**NSLPP MEETING HELD ON 05/04/2023****Attachments:**

ADDRESS/WARD: 37 Bay View Street, McMahons Point**APPLICATION No:** 418/21**PROPOSAL:** Erection of dwelling house and associated works**PLANS REF:**

OWNER: P Dugal**APPLICANT:** P Dugal, C/- Architecture Saville Isaacs**AUTHOR:** Jim Davies, Executive Planner**DATE OF REPORT:** 23 March 2023**DATE LODGED:** 3 December 2022**RECOMMENDATION:** Deferred Commencement

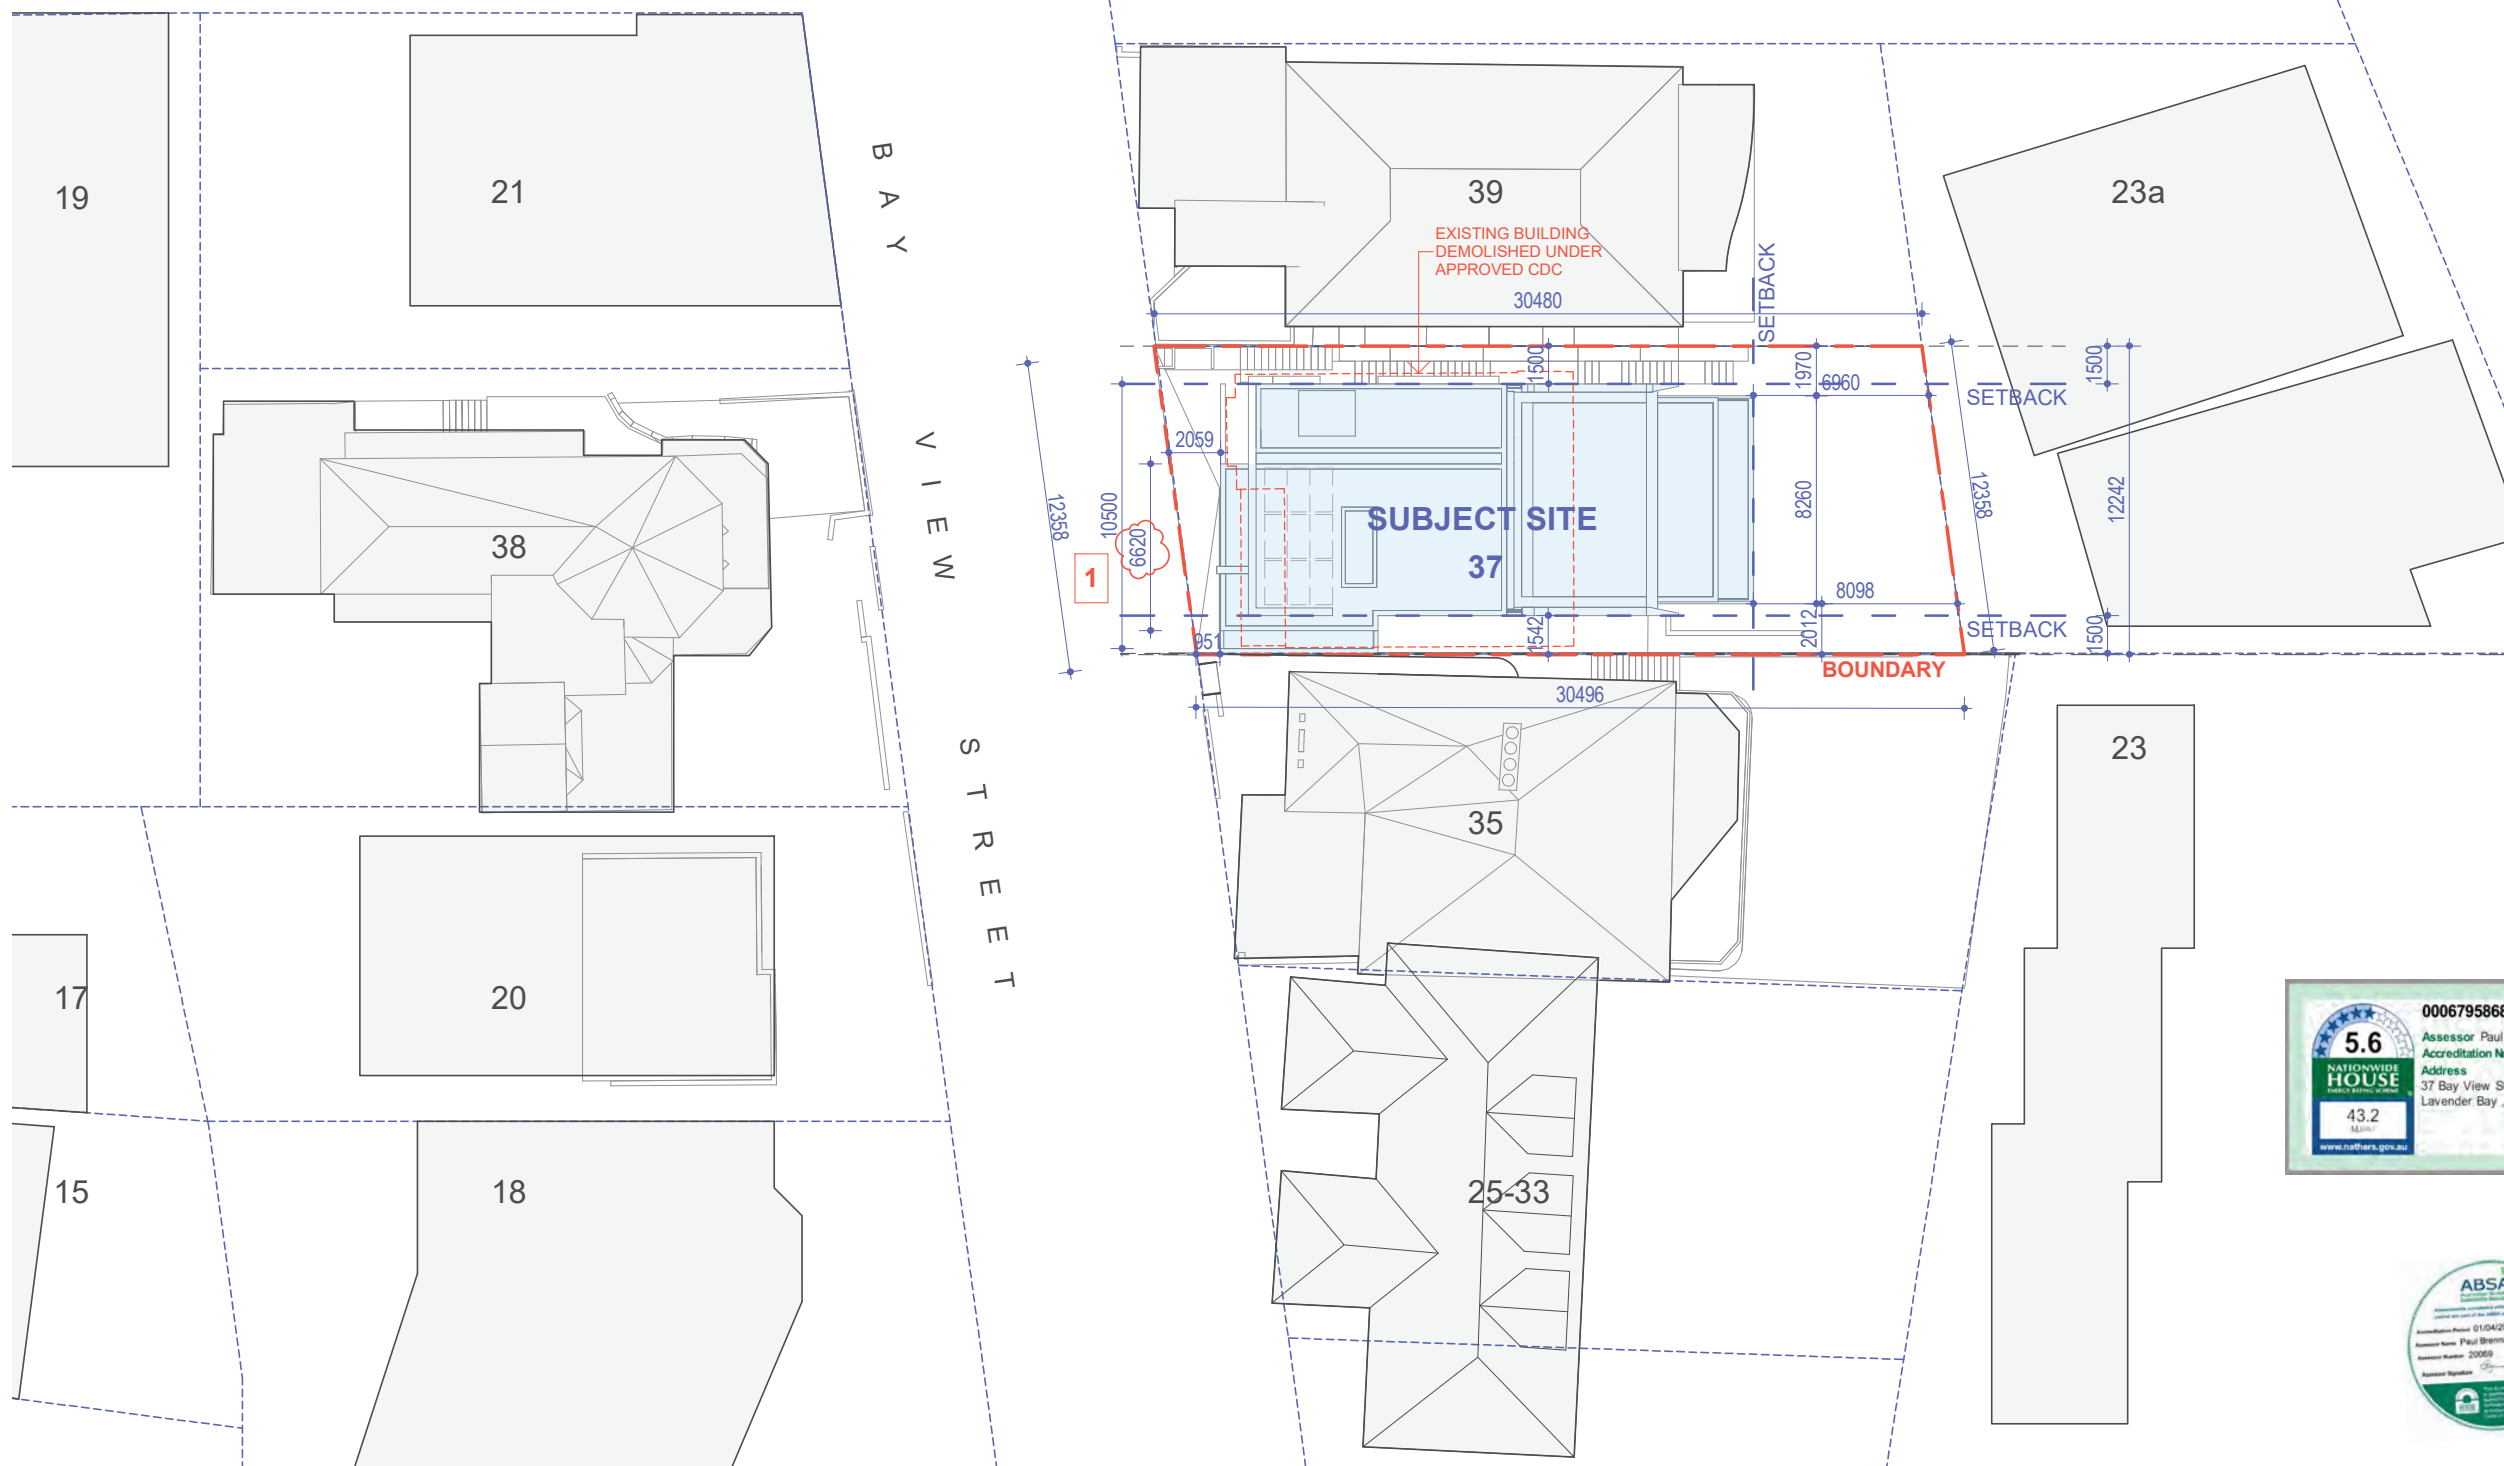
- 1 BUILDING BULK REDUCED

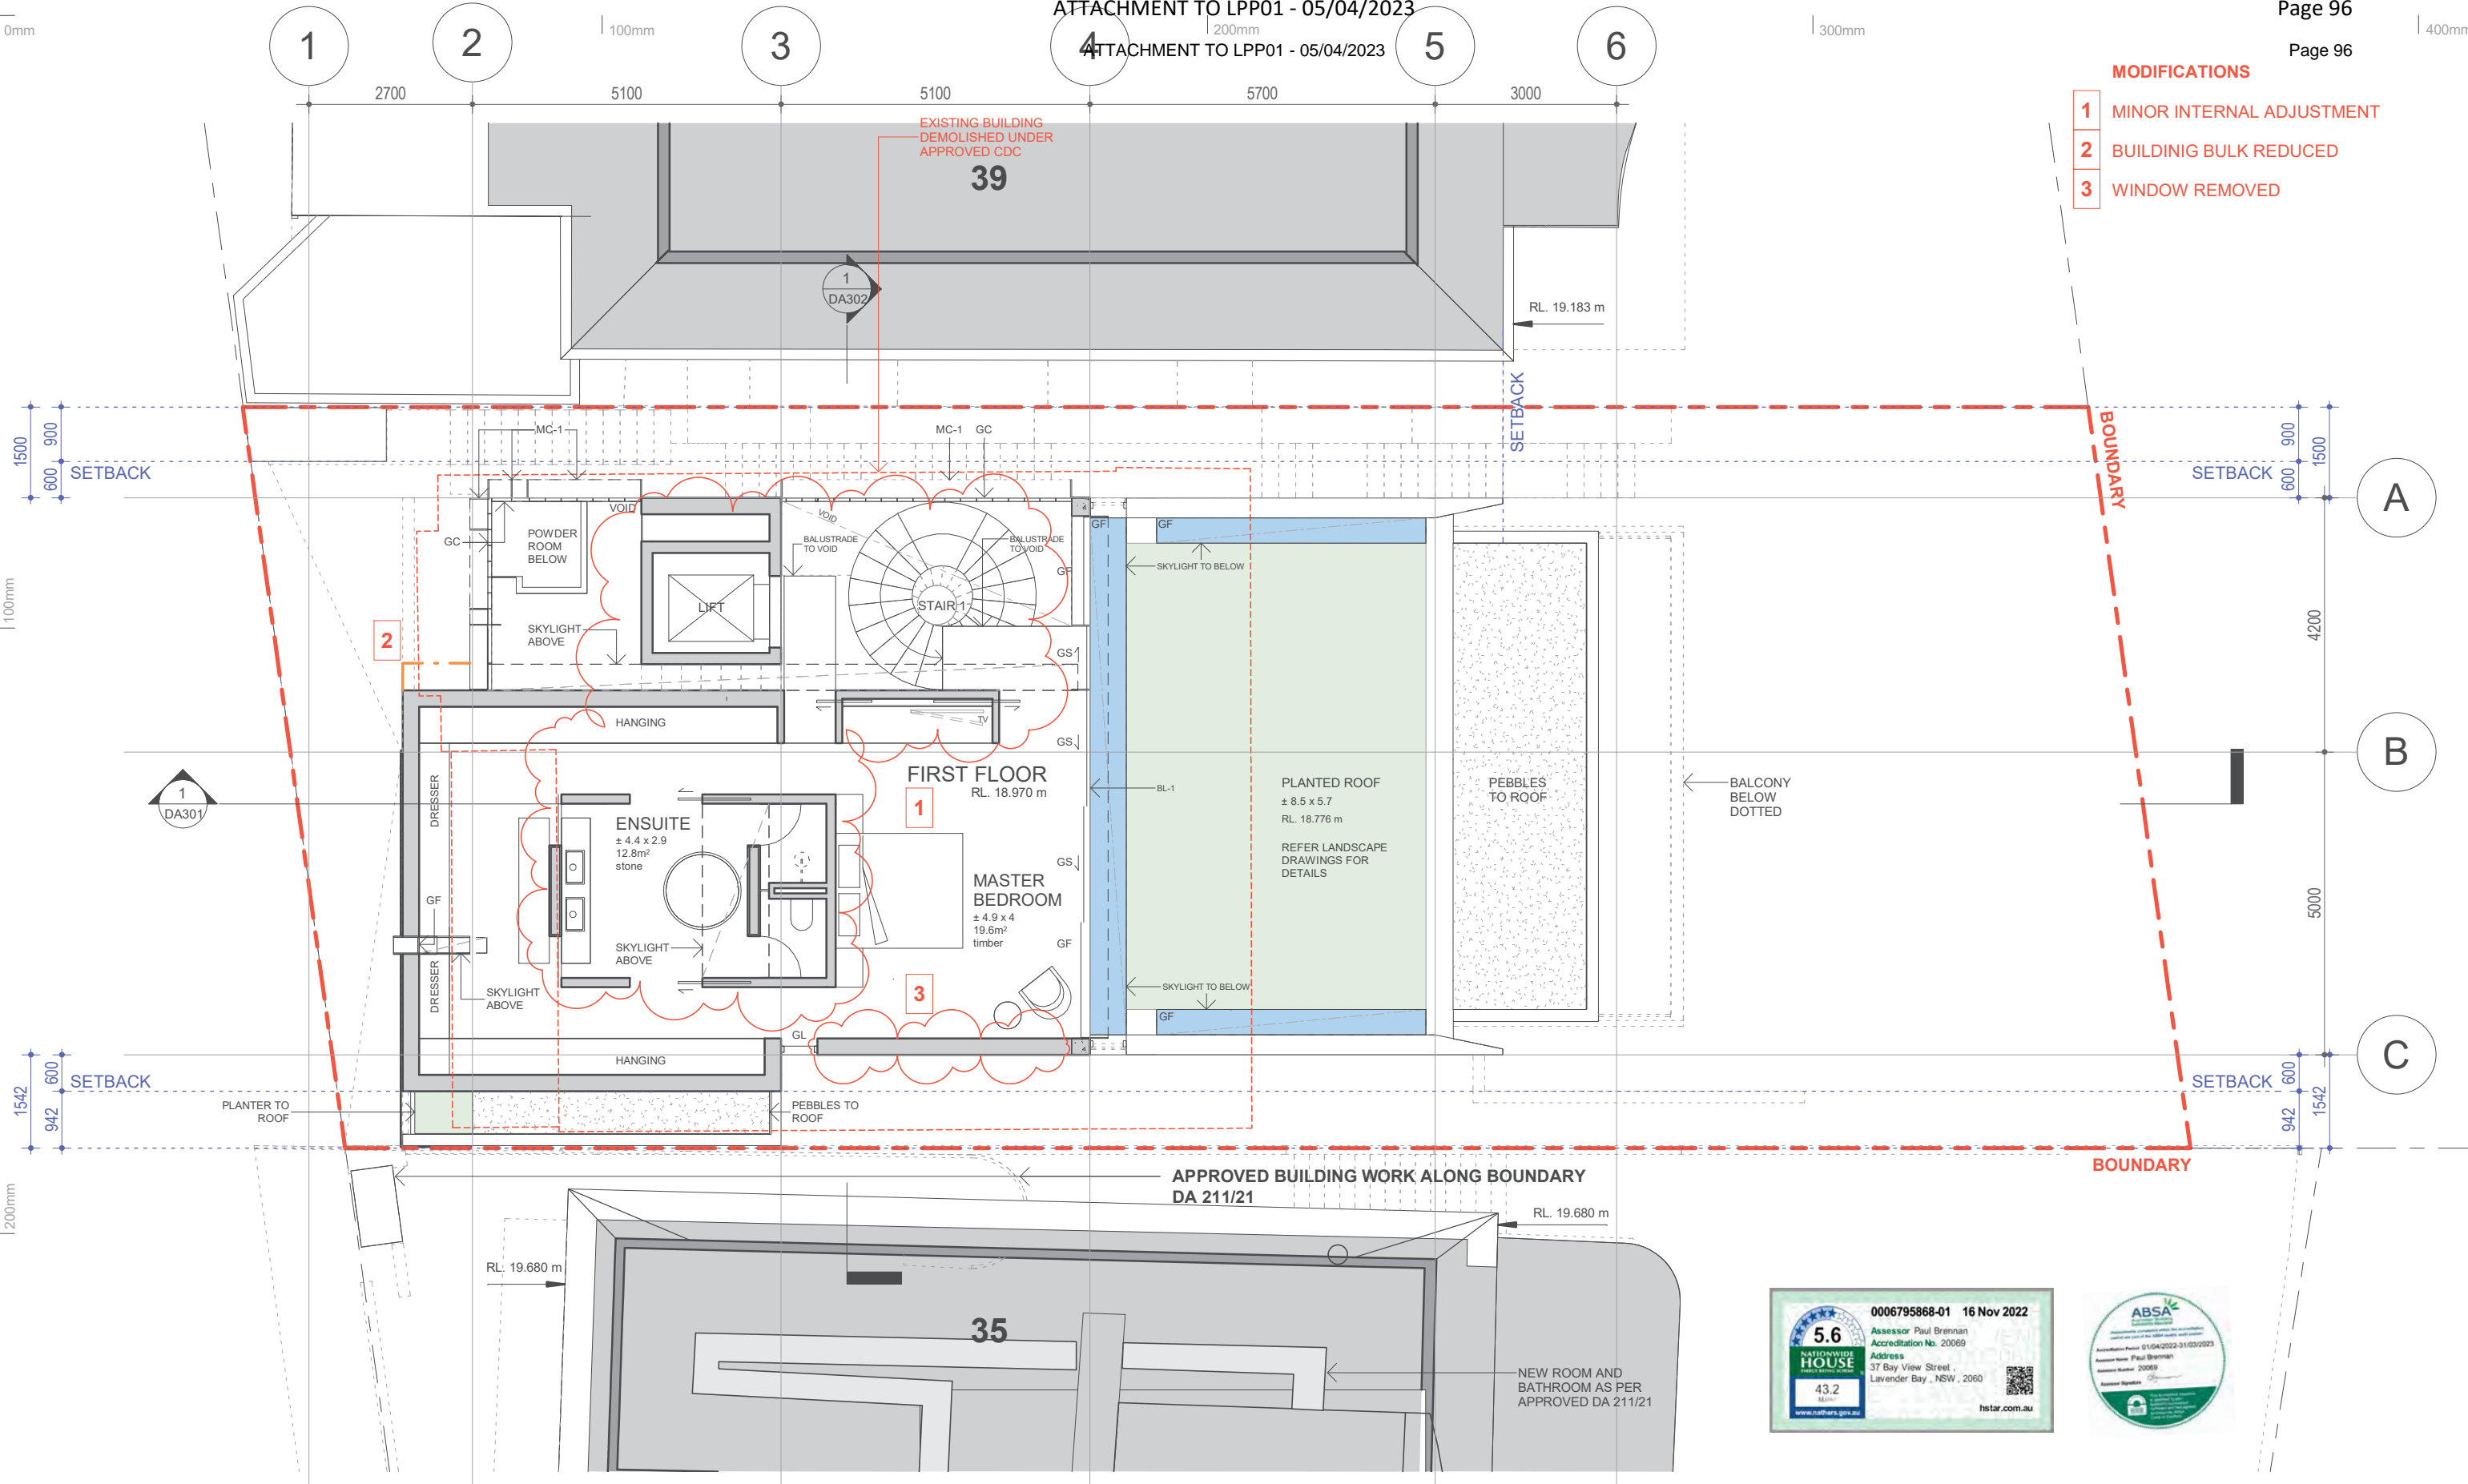
- MODIFICATIONS**
- 1** MINOR INTERNAL ADJUSTMENT
 - 2** BUILDING BULK REDUCED
 - 3** WINDOW REMOVED

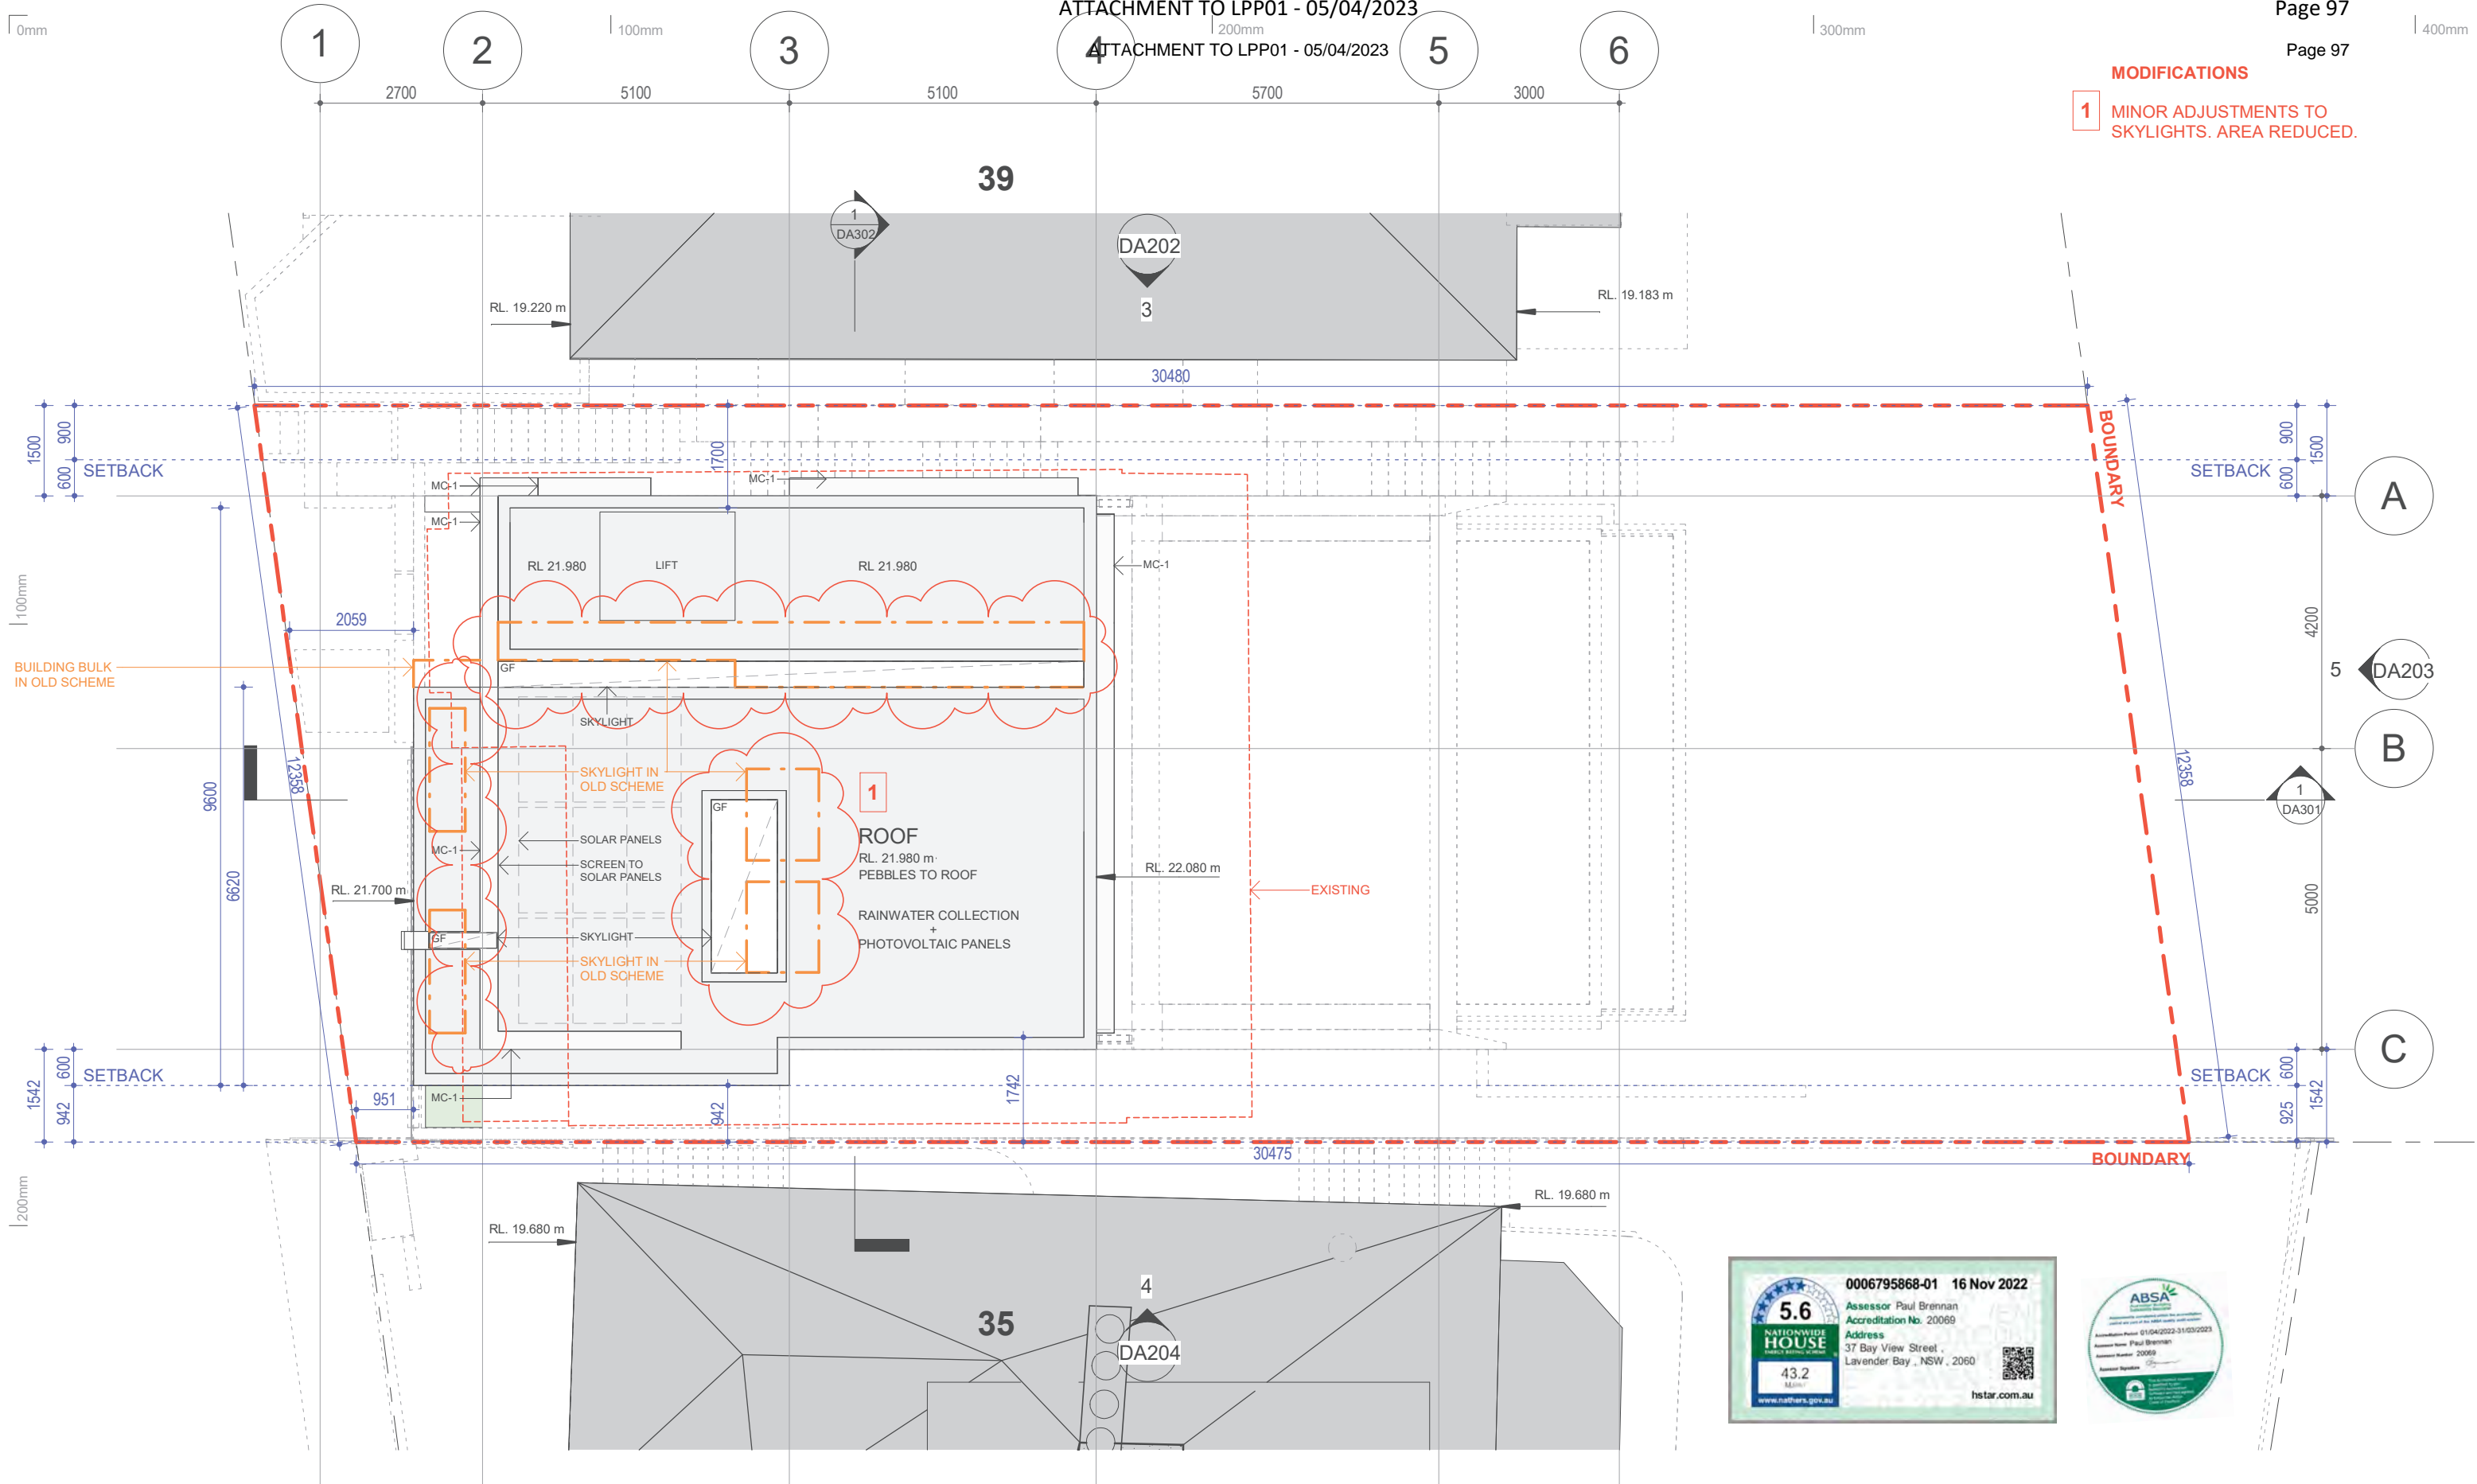
1 MINOR ADJUSTMENTS TO SKYLIGHTS. AREA REDUCED.
